Access Compliance Report

Public Rights-of-Way

(Curb Ramps)

Intersection ID: 45136	Main Street: LITTLE_WHITEOAK_RD	Cross Street: FAWN_CROSSING_CT	Location: SW
ADA ID: ED2678C2C3AB	Ramp Type: PerpDiag	Initial Pass/Fail: Fail	Overall Compliance: No
Severity Score: 17.5			
Codes/Mitigation Info/Possible Solution		Field Measurements/Component Compliance

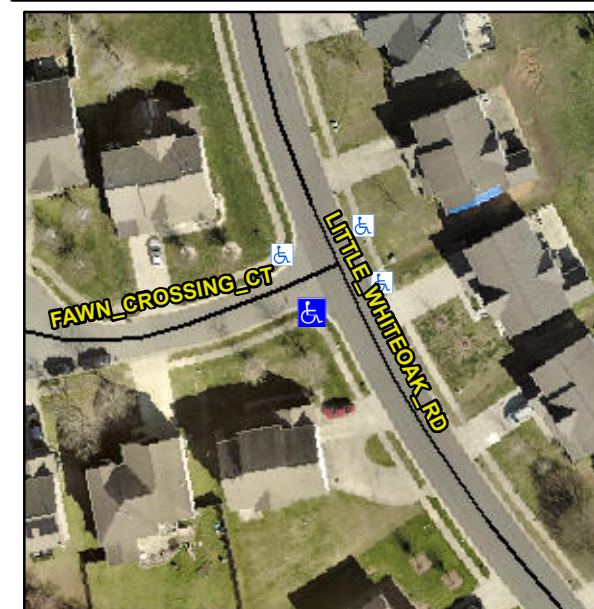
Not Found, R304.5.1

Compliance	Description	Data	Compliance	Description	Data
N/A	Ramp Length (in)	47.5	Yes	Ramp Slope (%)	5.0
No	Ramp Width (in)	34.0	Yes	Ramp XSlope (%)	0.6
N/A	Flare Type LT	N/A	N/A	Flare Type RT	N/A
N/A	Flare Slope LT (%)	N/A	N/A	Flare Slope RT (%)	N/A
N/A	Flare Traversable LT?	N/A	N/A	Flare Traversable RT?	N/A
N/A	Landing Length (in)	N/A	N/A	DWS Provided?	N/A
N/A	Landing Width (in)	N/A	N/A	DWS Contrast?	N/A
N/A	Landing Slope (%)	N/A	N/A	DWS Length (in)	N/A
N/A	Landing X Slope (%)	N/A	N/A	DWS Full Width?	N/A
N/A	Landing Curb? (Y/N)	N/A	N/A	DWS Offset (in)	N/A
N/A	Shared Landing?	N/A			
N/A	Gutter Ponding?	N/A	N/A	Gutter Slope (%)	N/A
N/A	Gutter Lip Ht (in)	N/A	N/A	Gutter X Slope (%)	N/A
N/A	Painted X Walk1?	No	N/A	Painted X Walk2?	No
	X Walk 1 Direction	To E		X Walk 2 Direction	To N
N/A	X Walk 1 Width (in)	N/A	N/A	X Walk 2 Width (in)	N/A
	X Walk 1 Slope (%)	2.7		X Walk 2 Slope (%)	3.8
	X Walk 1 X Slope (%)	4.0		X Walk 2 X Slope (%)	1.2

Remove & Replace Curb Ramp With Two New Directional Ramps or Equivalent.
